ADDENDUM NO. 03 5 April 2010

Project: **A NEW TRANSPORTATION FACILITY**
Dickinson Independent School District

Project No.: **0806**

4. This Addendum consists of two (2) 8-1/2x11 written pages, and two (2) 30x42 attached full size sheets; **S1.1** and **S1.2**; as prepared by Concept Engineers. Total pages: 4 pages.

S1.1
FOUNDATION PLAN & DETAILS
CHILD NUTRITION BUILDING

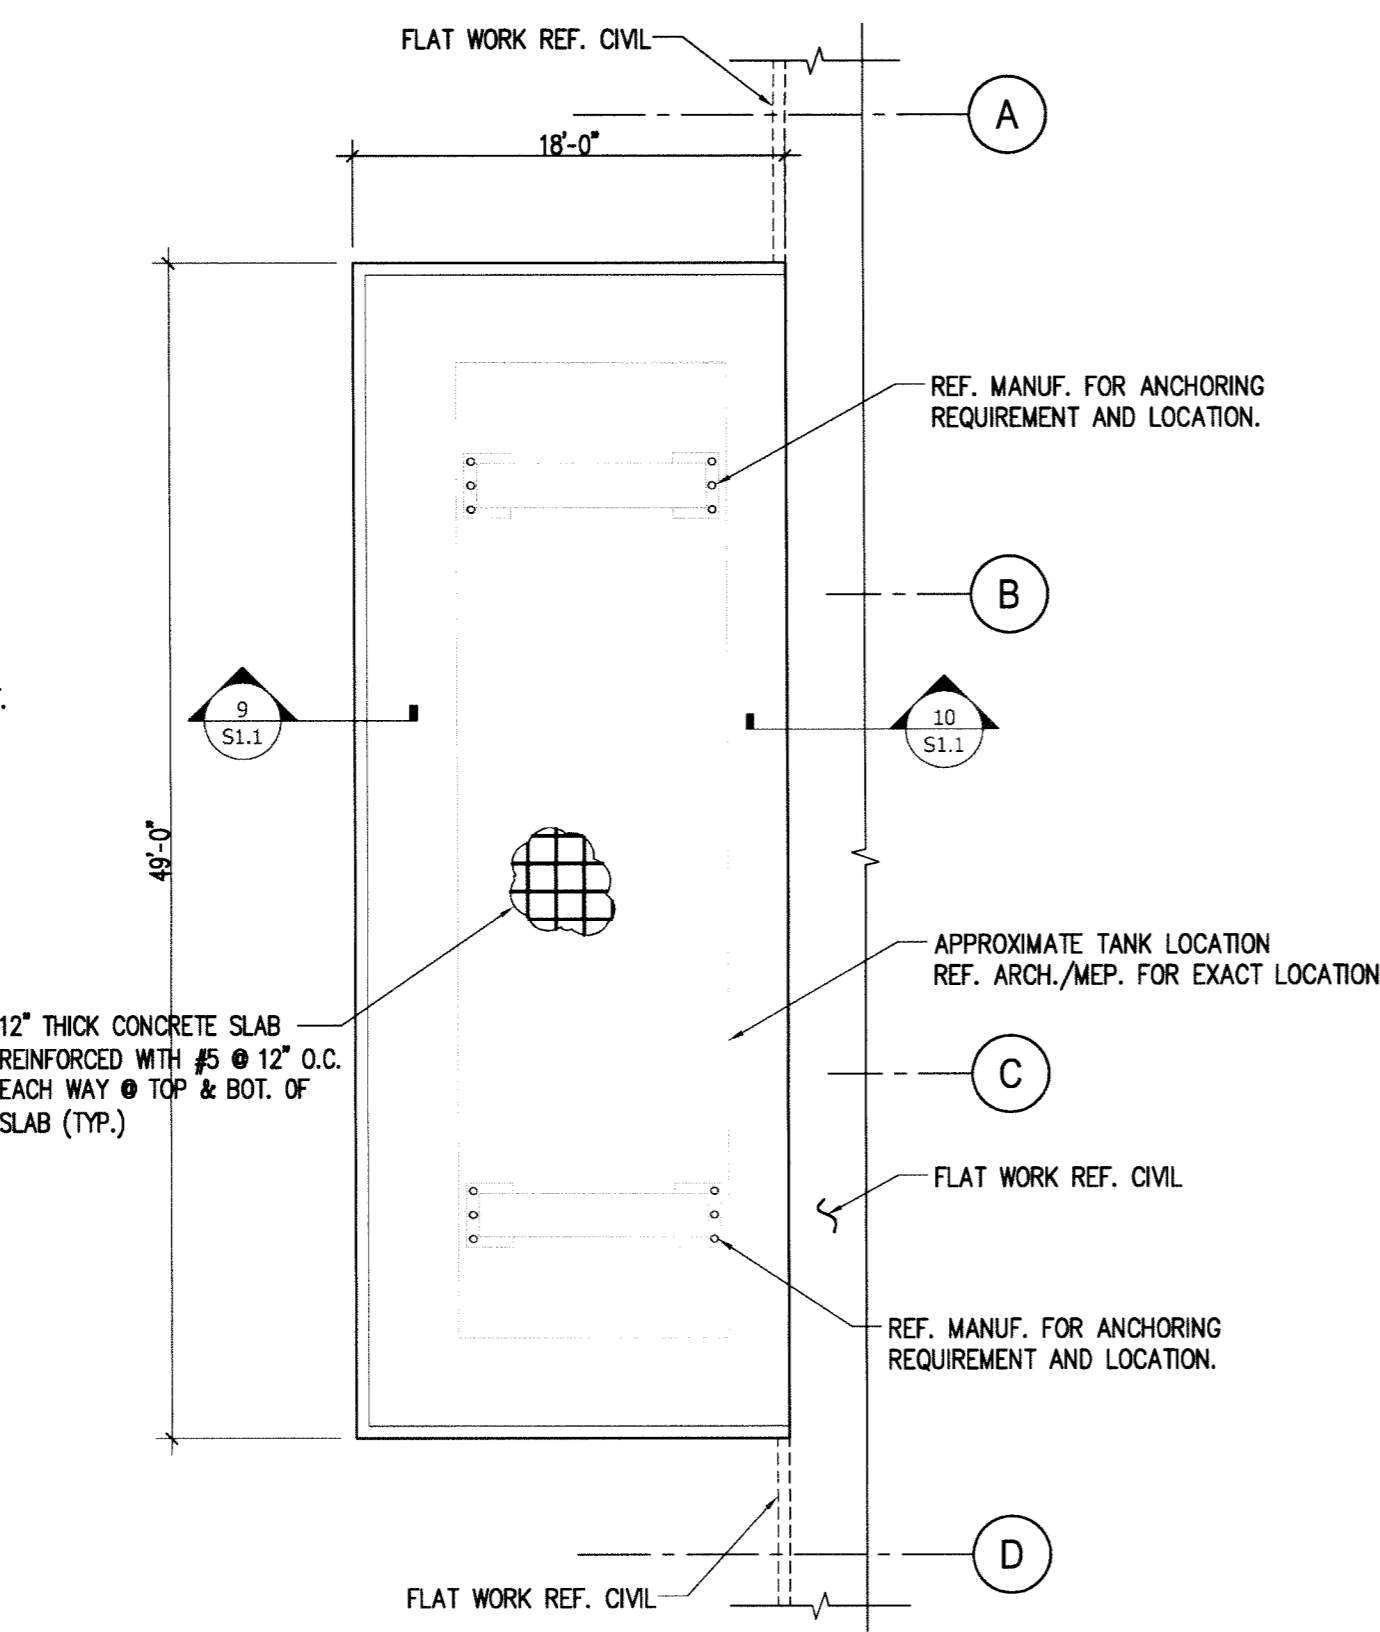
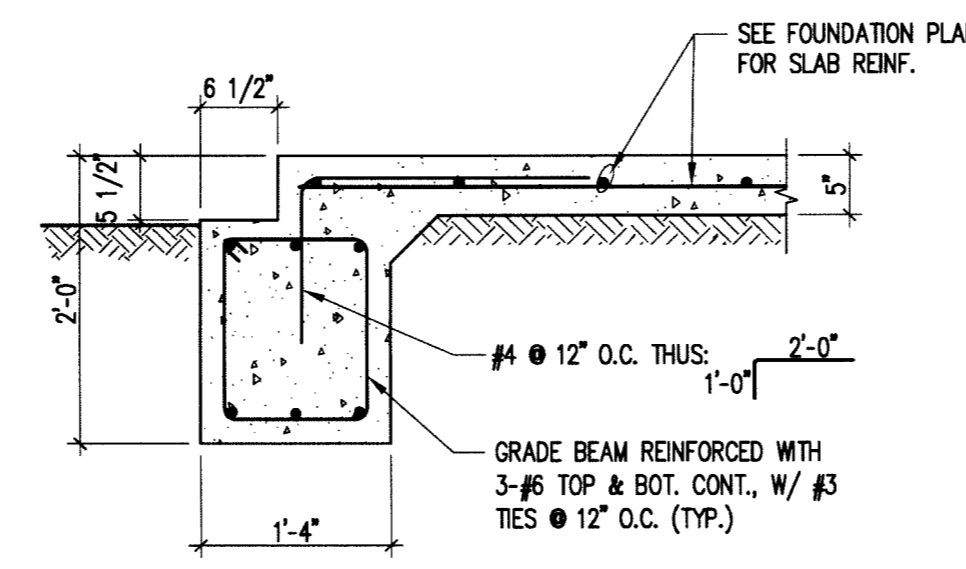
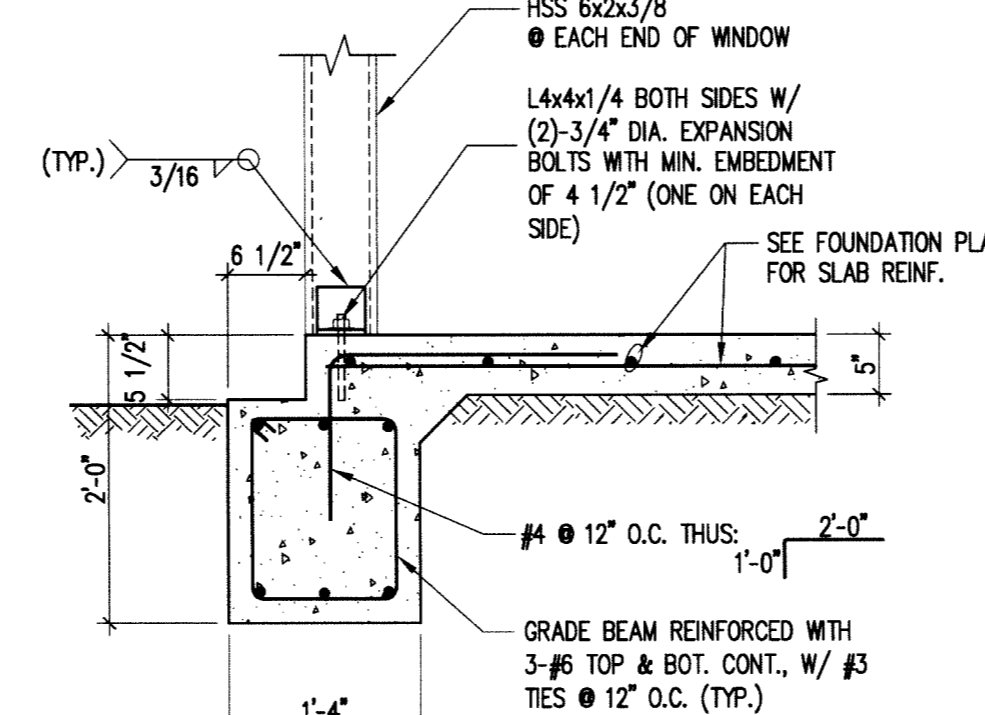
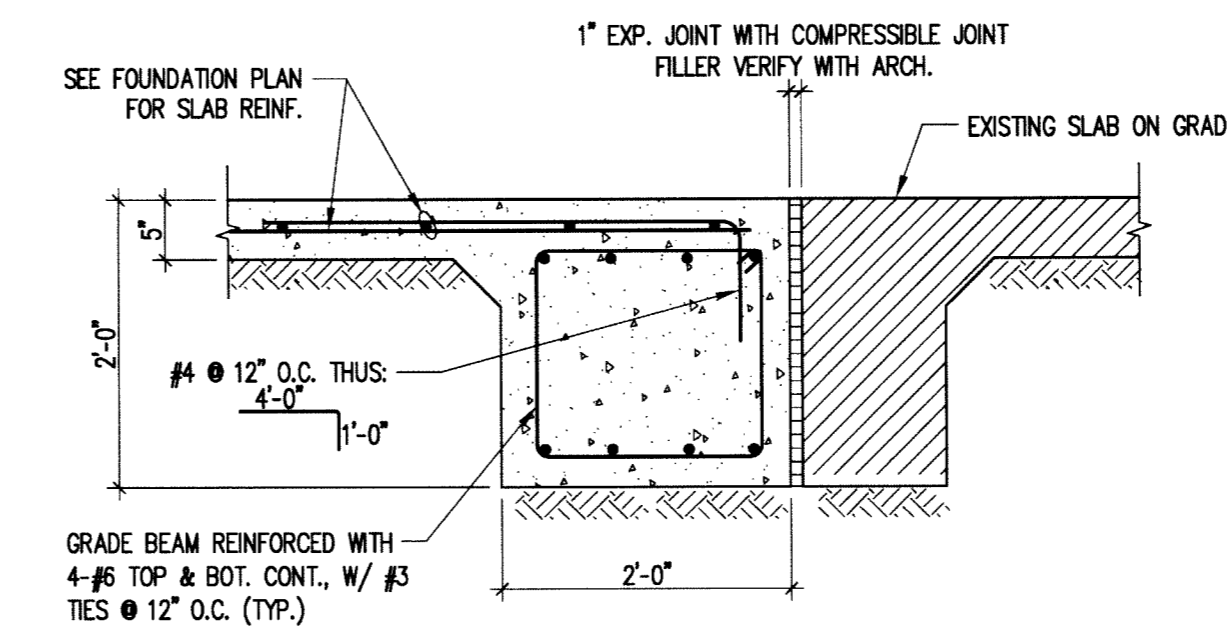
8. Sheet S1.1 Foundation Plan & Details Child Nutrition Building: Add foundation plan and details of entrance area of Child Nutrition Building. Also add the foundation plan and details to support fuel tank at fuel dispensing area.
9. Sheet S1.2 Roof Plan and Details Child Nutrition Building: Add roof framing plan and details of entrance area of Child Nutrition Building.
